Agenda Item Staff Report

Subject: **Metro Gold Line Foothill Extension Azusa to Montclair Project (Phase 2B)**

Bonita/Cataract Intersection Grade Crossing

Future Station and Parking - San Dimas

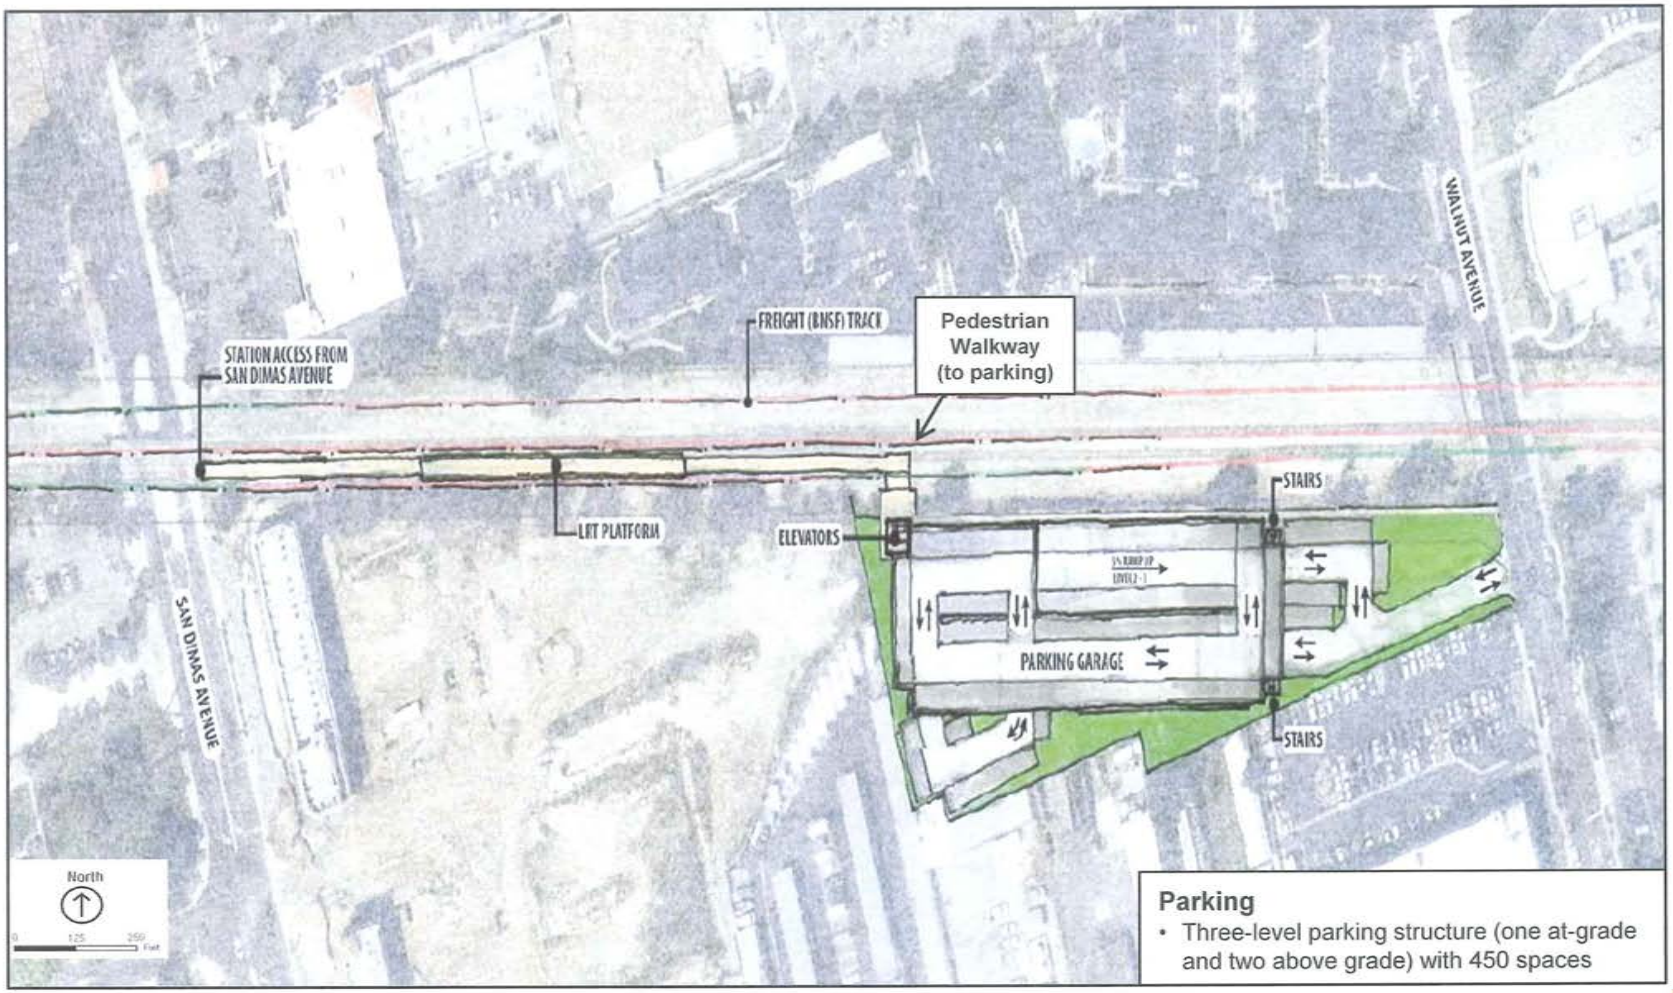
1. *Station location.* East of San Dimas Avenue, rear of Grove Station or otherwise known as Village Walk HOA. Is there a City Council consensus to keep this preferred designated location, **or** do we direct the Construction Authority to review other locations considered back in 2006/7. Some of these were:
    a. M&E Property located at north corner of Bonita/Cataract
    b. West of San Dimas Ave north of existing Park & Ride facility

2. *Parking structure (City Maintenance Yard).* While the proposed parking structure through the DEIR/EIR stage of the project development was located at the City Maintenance Yard, the proposed location does severely impact the City Maintenance Yard operations and other nearby Public and Private Properties as follows:

- ***Impact on City Maintenance Operations.*** The maintenance operations conducted at the site are critical to the daily ongoing operations of the City. The current location is ideally situated proximate to administrative operations at City Hall and relatively central to the City as a whole. It is difficult to identify a feasible site to replace the current one and maintain these same standards.

- ***Site Circulation:*** Ingress/egress access to structure from Walnut Avenue may restrict right-turn exit movements from parking garage driveway to Walnut Avenue due to possible safety medians at the grade crossing. The median may also restrict ingress/egress to the Sunnyside (located at 251 North Walnut Avenue) Senior complex. In addition, for efficient circulation and flow, an alternate egress should be evaluated that connects to Arrow Highway from the parking structure.

- ***Impact to Emergency Services:*** With the Sheriff Sub Station and Fire Department located on Walnut Avenue north of grade crossing and parking structure. It quite apparent that emergency access services to the south will likely be adversely affected by a combination of the periodic at- grade crossing gate closures for operations and a confusing circulation pattern/increased traffic at AM/PM peaks. While the Authority will evaluate impact to Sheriff, and Fire and Paramedics response time at proposed crossing/parking structure location. The proximity is still concern.

- ***Other Potential Issues Created by Limited and Restricted Entrance of Walnut Avenue.*** With limited street frontage and long driveways that lead to main parking structure limits the ability to provide any pickup/drop off zone. In addition, with pedestrian access to station being from San Dimas Avenue will likely result in extensive over use of both the private (CVS) and Municipal parking lot north of the tracks as well as the parking area at Grove Station for pickup/drop off zone. This intense use will also increase in commuters parking in these lots and place great deal of strain on the availability of parking for existing business. To mitigate these issues consider option for additional parking including the feasibility of expanding the City municipal parking lot north of tracks for additional parking/drop off and pickups by expanding south into existing Metro Gold Line right of way.

3. *Consideration of other parking structure locations.* Instead of the City Yard, explore the feasibility of an equivalent spaced structure that incorporates the required commuter parking, existing parking and the pickup/drop-off zone off Arrow Highway. Or incorporate something within City municipal parking lot located on the northwest corner San Dimas Avenue and rail crossing.

GOLD LINE FOOTHILL EXTENSION
PRELIMINARY ENGINEERING
GRADE CROSSING AT
W. BONITA AVE. AND CATARACT AVE.
ALTERNATIVE NO. 1

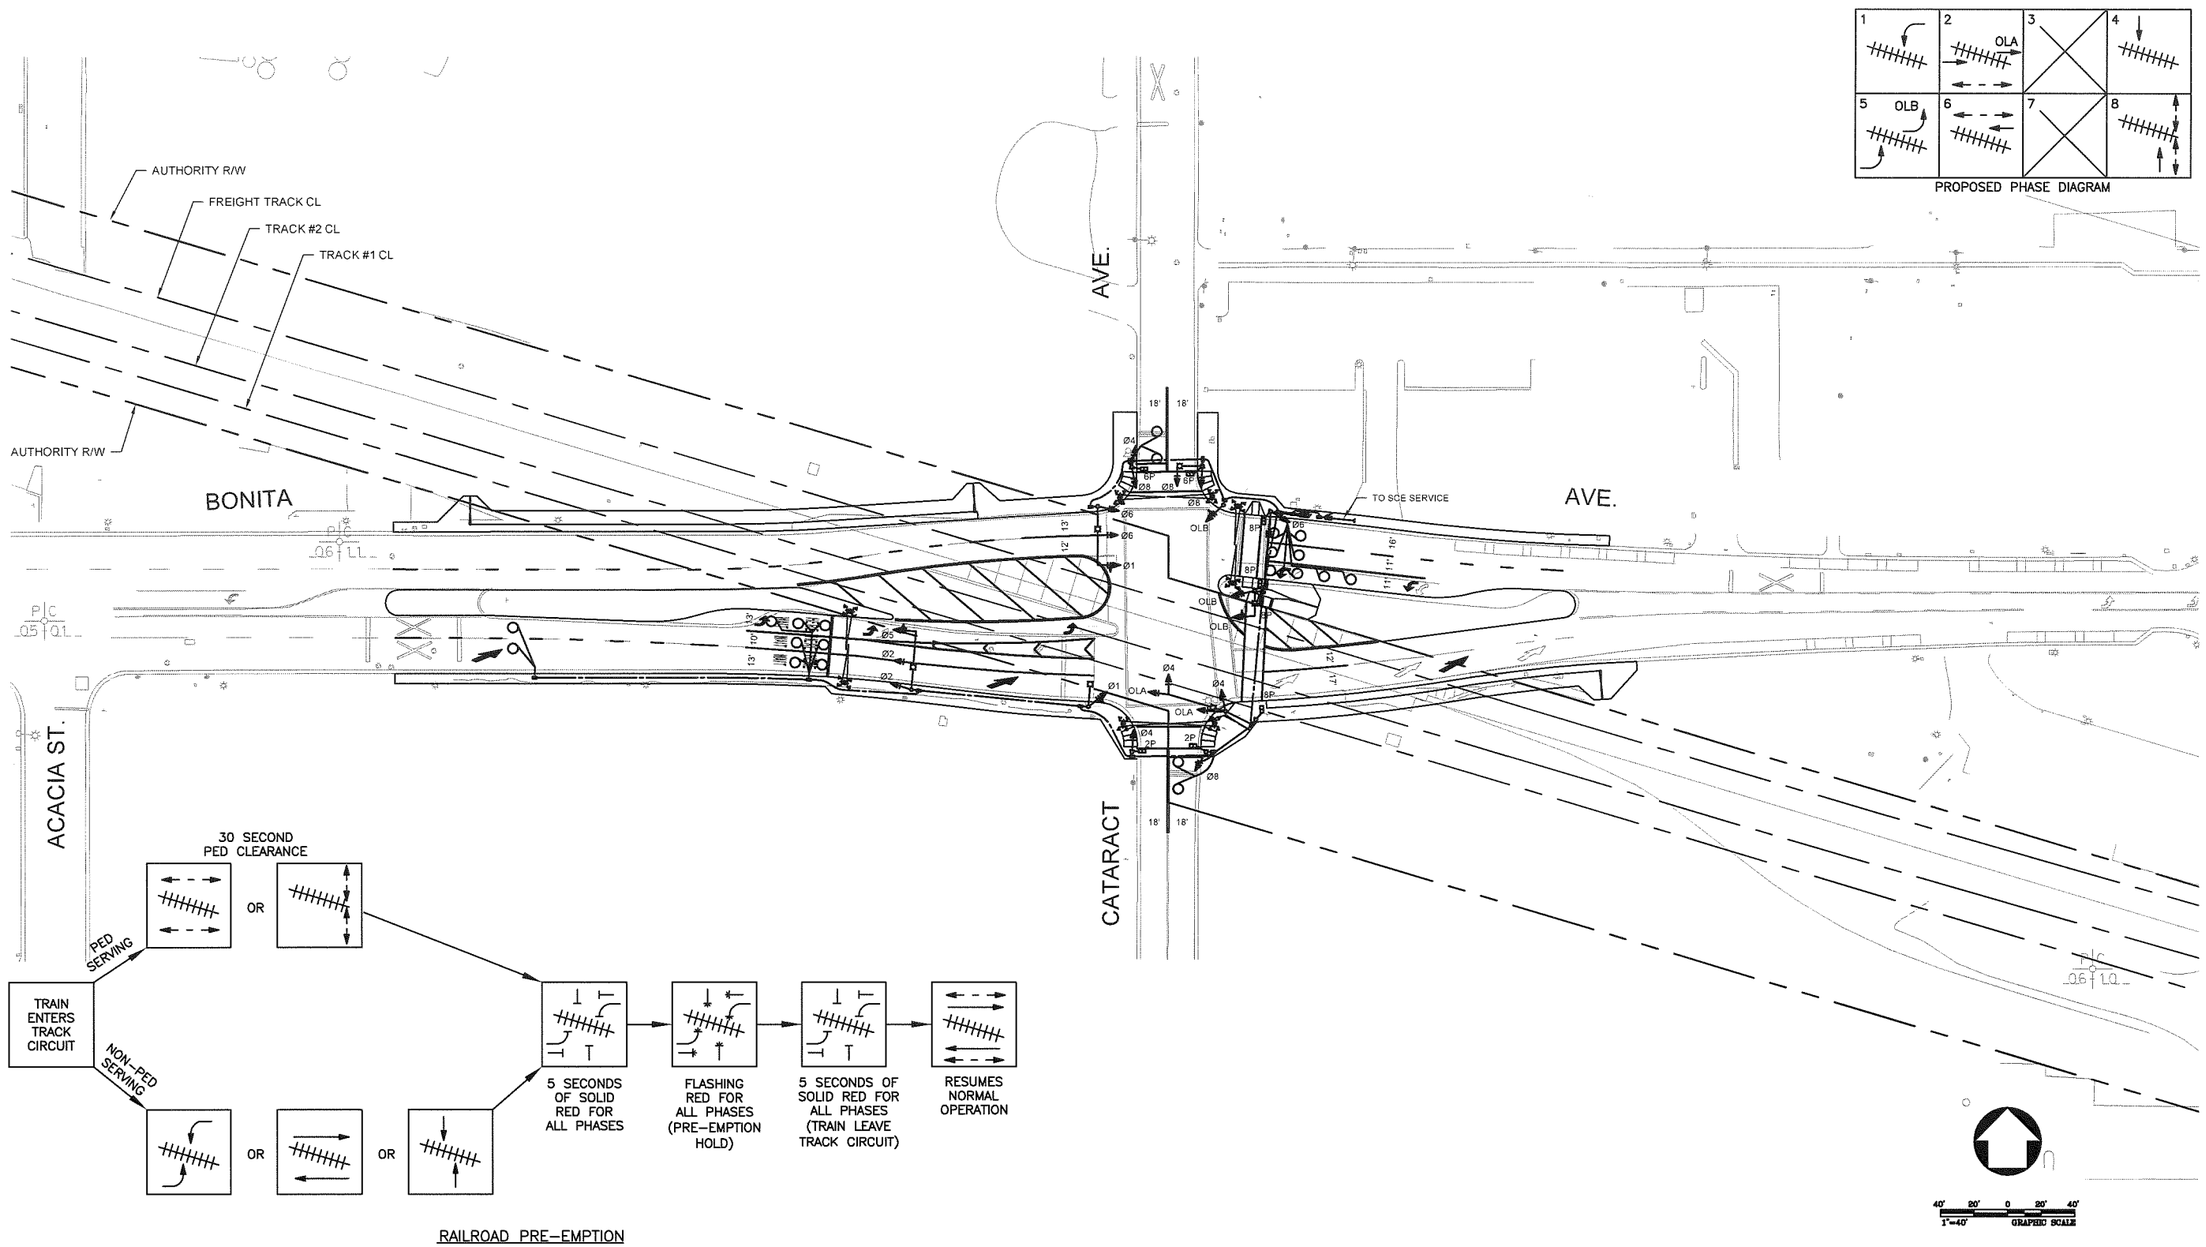
Alternative 1 would entail all improvements more or less similar and staying within existing north/south curb line of Bonita, but where the westerly center median is cut back approximately 100 feet. The distance between east and west crossing gates on Bonita is about 250 feet. This would result in following pros and cons in terms of improvements.

- *Cons*
  - Large areas of pavement striped will promote unsafe turns
  - Increased traffic delays during non-peak times
  - Signal equipment on north east side in front of business on Bonita
  - Long delays with protected left turns
  - Ped peak of travel across Bonita too long
  - Ped crossing problematic for visually impaired when LRT and freight trains cross at same time
  - Since No curb and gutter on tracks; ADA problems for visually impaired
  - Wheelchair ramp/crosswalk conflict with the track - difficult to mitigate ADA path of travel or comply with standard
  - Lane drops before intersection – high potential for sideswipes
  - Signal pole conflict with track clearance – overhead/mast arm conflict

Pros:

- Ped monument across intersection shorter
- Westbound traffic will clear slightly quicker

GOLD LINE FOOTHILL EXTENSION
PRELIMINARY ENGINEERING
GRADE CROSSING AT
W. BONITA AVE. AND CATARACT AVE.
ALTERNATIVE NO. 2

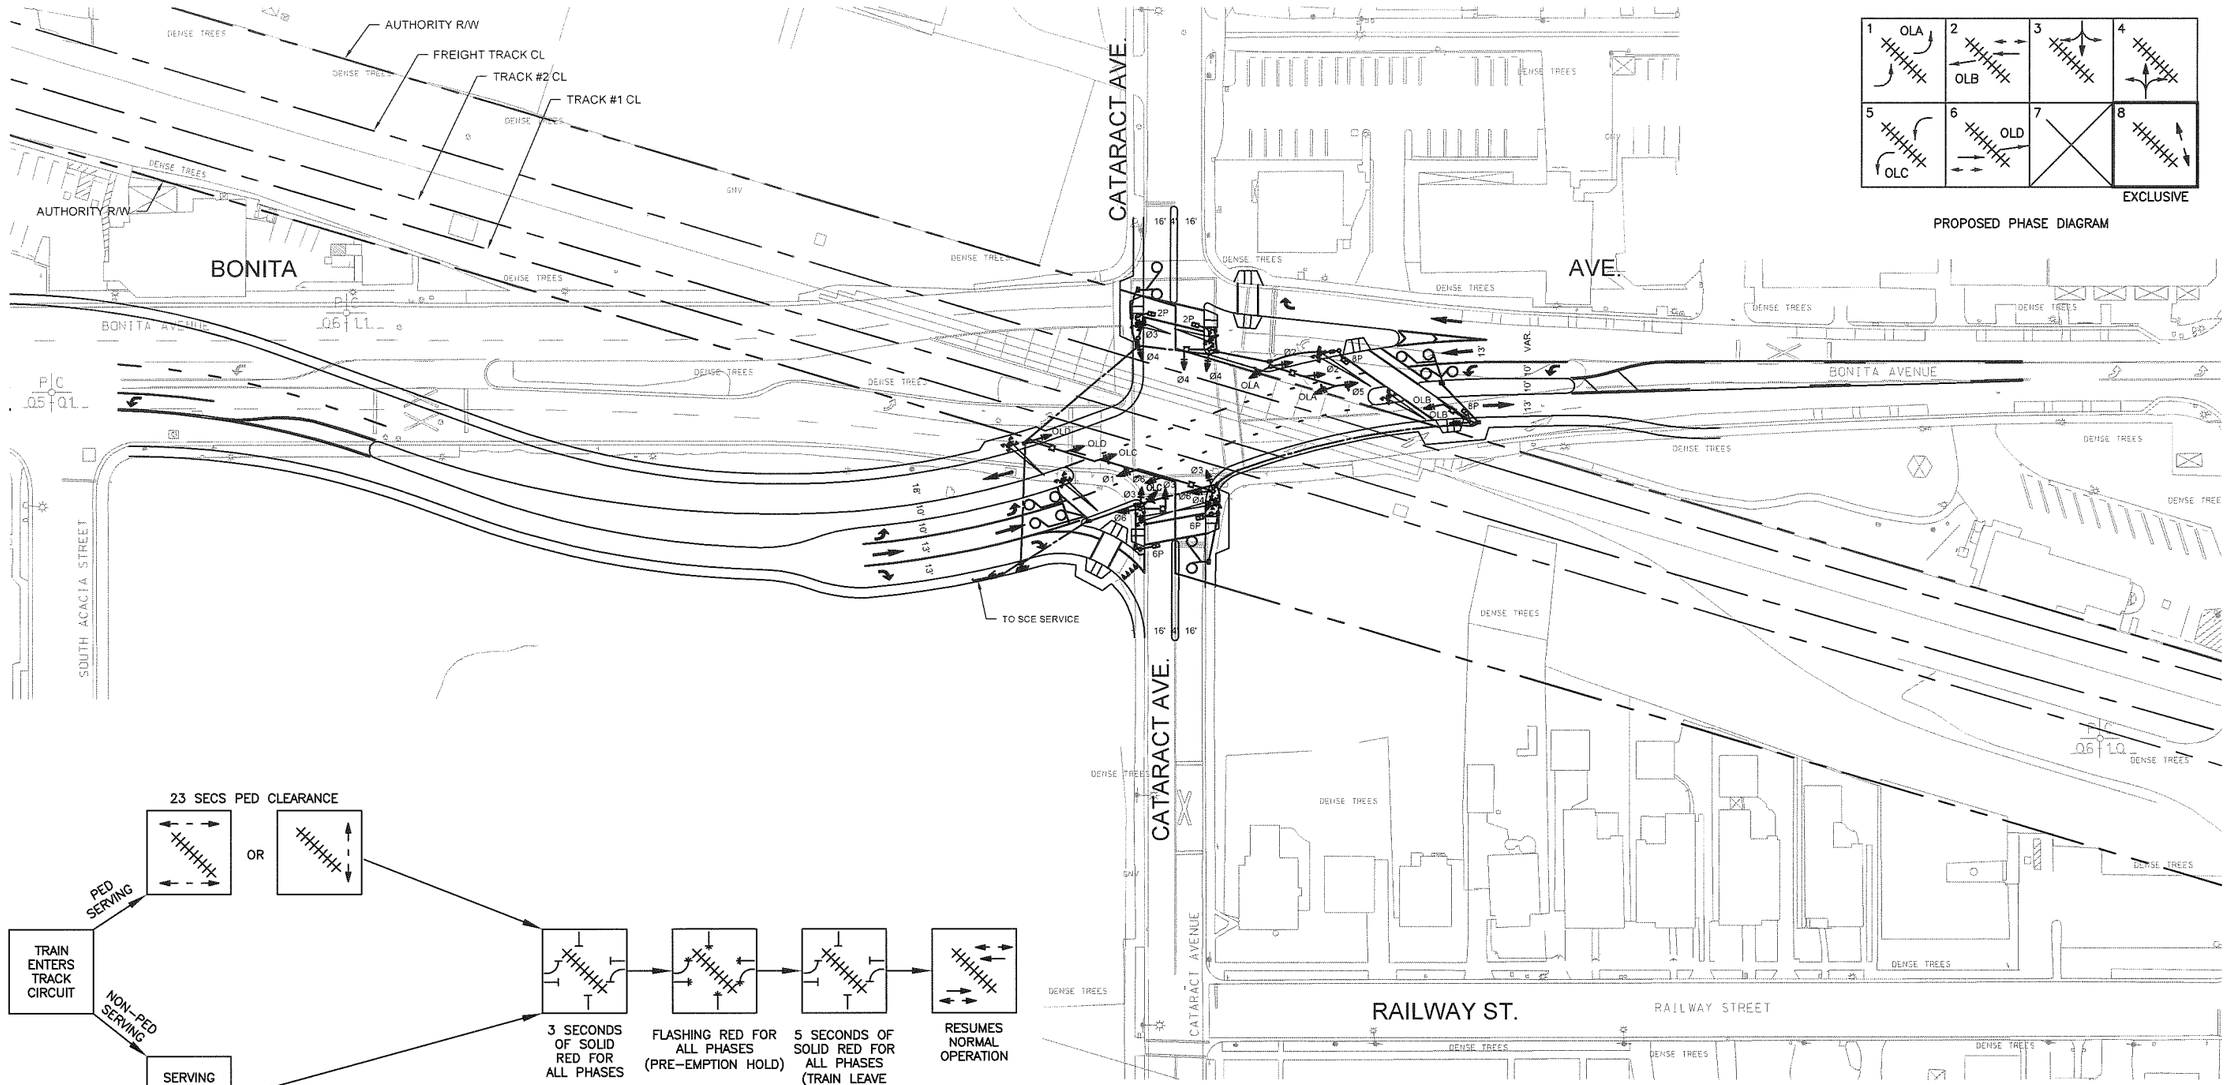
Alternative 2 would entail redesign of the intersection with shifting of the entire eastbound/westbound lanes west of Cataract being shifted approximately 80 feet south of the existing southerly east bound curb of Bonita. This would result in following pros and cons in terms of improvements.

Cons:

- Crosswalk requires more preemption at north east side on Bonita
- Long pedestrian path of travel
- Increased delays with protected left turns
- No business parking on north side of Bonita
- Traffic may detour to Railway Street to avoid intersection delays
- Challenging for traffic flow to turn right from southbound Cataract when no curb return across tracks and panels; also challenges for ADA and visibly impaired

Pros:

- Better traffic flow movement for eastbound, least eastbound conflict
